## Product Change Notification / SYST-08DHB472

ERRATA - PIC18F26/46/56Q84 Silicon Errata and Data Sheet Clarifications

# PIC18F26/46/56Q84 Silicon Errata and Data Sheet Clarifications

### 1.6.1 UART TXDE Signal May Go Low Before the STOP Bit Has Been Entirely Transmitted

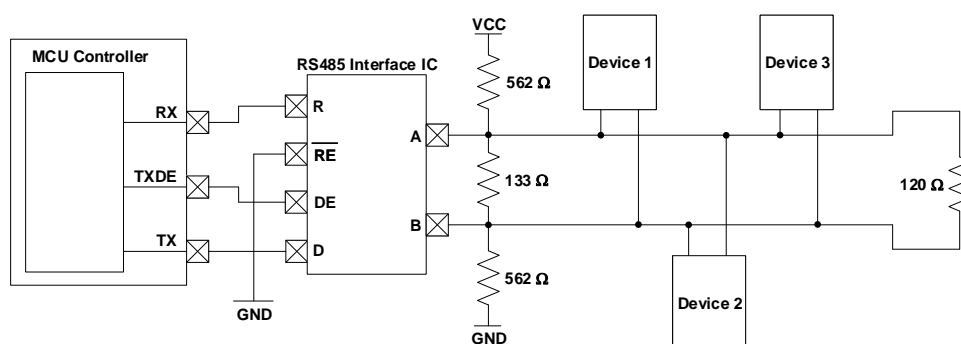
The UART Transmit Drive Enable (TXDE) signal could potentially transition into a low state before the UART STOP bit has been entirely transmitted due to the effects of parasitic capacitance on the TX line. In some applications, this could result in communication being prematurely terminated due to the TXDE bit going low before the STOP bit has had enough time to settle.

To ensure that the STOP bit settles into its final logic state before the TXDE signal transitions low, a biasing circuit can be implemented. A biasing circuit allows the TX line to either be driven high or low, rather than being left in a floating tri-state mode where prolonged rise or fall times could lead to communication being disrupted. This bias circuit should only be implemented on one end of the serial bus, and a termination resistor should be used on the other end. The figure below shows an example of a bias circuit that can be used to achieve this.

Please note that the resistor values used in this circuit are recommendations, and that the actual resistor values required may vary based on the application.
